RE: **534 South Palmway**

TITLE: **HRPB Project Number 20-00100126:** Consideration of a Certificate of Appropriateness (COA) for window and door replacement for the property located at **534 South Palmway**; PCN#38-43-44-27-02-000-0010. The subject property is a contributing resource to the South Palm Park Local Historic District and is located in the Single-Family (SF-R) Zoning District.

West Elevation (Fronting South Palmway)

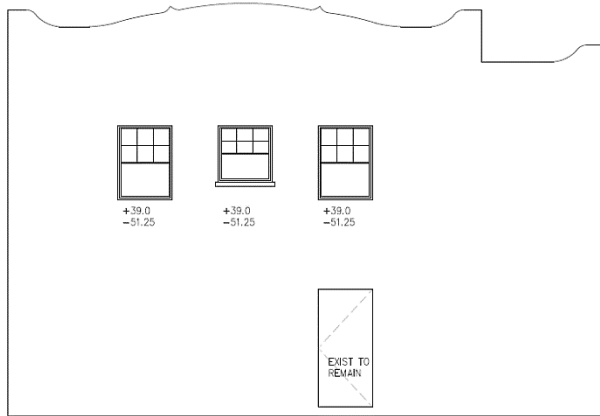
Proposed

Install new vinyl impact single-hung windows with a 4/1 divided-light patterns.
Install new aluminum impact French doors (10-light).

- Window Frame: Vinyl
- Door Frame: Aluminum
- Window and Door Frame Color: White
- Muntin Type: Exterior Raised
- Glass Type: Clear or Clear Low-E

Staff Recommendation (Most Successful Replacement)

Install new wood, wood-clad, or aluminum impact single-hung windows with a 3/1 divided-light patterns and two-part (50-50) horizontal rollers or casement windows with 8-lights per leaf to replicate the appearance of the original windows types. Install new wood, wood-clad, or aluminum impact French doors (10-light).

- Window Frame: Wood, Wood-clad, or Aluminum
- Door Frame: Wood, Wood-clad, or Aluminum
- Window and Door Frame Color: White or Bronze
- Muntin Type: Exterior Raised Triangular
- Glass Type: Clear or Clear Low-E

NORTH ELEVATION 3
 SCALE: 3/16" = 1'-0" A6

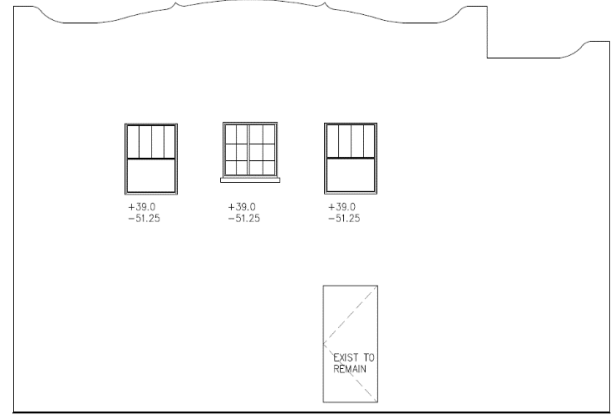
Proposed

Install new vinyl impact single-hung windows with a 6/1 divided-light pattern.

- Window Frame: Vinyl
- Window and Door Frame Color: White
- Muntin Type: Exterior Raised
- Glass Type: Clear or Clear Low-E

Staff Recommendation (Most Successful Replacement)

Install new wood, wood-clad, or aluminum impact single-hung windows with and 4/1 divided-light pattern and two-part (50-50) horizontal rollers or a pair of casement windows with 6-lights per leaf to replicate the appearance of the original windows types.

- Window Frame: Wood, Wood-clad, or Aluminum
- Door Frame: Wood, Wood-clad, or Aluminum
- Window and Door Frame Color: White or Bronze
- Muntin Type: Exterior Raised Triangular
- Glass Type: Clear or Clear Low-E
